December 2022 Changes to Proposed Development at 109 Palmerston St Perth

SUMMARY

Figure 4. Overshadowing of 107 Palmerston St. caused by the Fig tree in Robertson Park June 3, 2022.

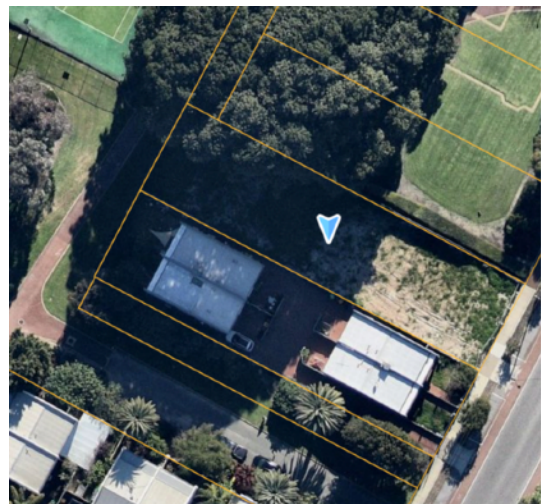
e) Clause 5.4.2 of the R Codes in relation to Solar Access for Adjoining Sites. The development has not been appropriately designed to protect the neighbouring property's (No. 107 Palmerston Street) access to direct sunlight to outdoor living areas and major openings, and would adversely affect the amenity of the neighbouring property;

- The site is heavily overshadowed from the North by the neighbouring fig tree, therefore solar access from the North is not possible for the rear neighbouring homes or the courtyard between the homes. Figure 4 shows the overshadowing caused by the tree taken on June 3, 2022.

- All the North facing windows on the rear neighbouring unit are overshadowed by the Fig tree in Robertson Park (Figure 4). Our development will not cast any additional overshadowing on the rear unit.

- The neighbouring properties are setback only 1m from their North boundary. This proximity means that their North facing walls will be shaded regardless of our overshadowing percentage. Overshadowing of 20% or 60% will have the same shading effect on the North facing walls, therefore meeting the deemed to comply value of 50% would not achieve the desired outcome of the Design Principles.

- The front RHS unit has one major opening facing North. (The other large window on the North is located on the staircase landing and is therefore not a major opening). We have preserved North facing solar access to the major opening of the front unit with a 5.6m wide gap between our units which is aligned with the window in question (Figure 5.) This room also has an additional window facing North West so it will have ample solar access during various times of the day.

Figure 5. Location of neighbouring property windows in relation to the proposed development. The yellow circle shows the only major opening with existing North facing solar access.

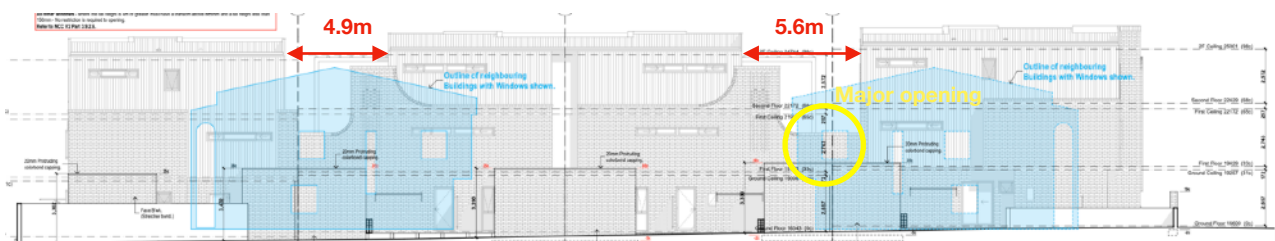
b) Clause 5.1.3 of the R Codes in relation to Lot Boundary Setbacks. The proposed development would adversely affect the amenity of the neighbouring property at No. 107 Palmerston Street because it would not maintain adequate access to direct sun into buildings and open spaces, and the proposed development has not been appropriately set back from the south western lot boundary nor designed to reduce the impacts of building bulk and scale;

- Our proposal has maintained the flow of air and dappled light to the neighbouring properties by providing meaningful spacing between the units. These have been aligned with the windows of the neighbouring property, to decrease the impact of bulk and scale (Figure 5). Hit and miss brickwork feature walls to parts of this area provide visual interest and privacy.
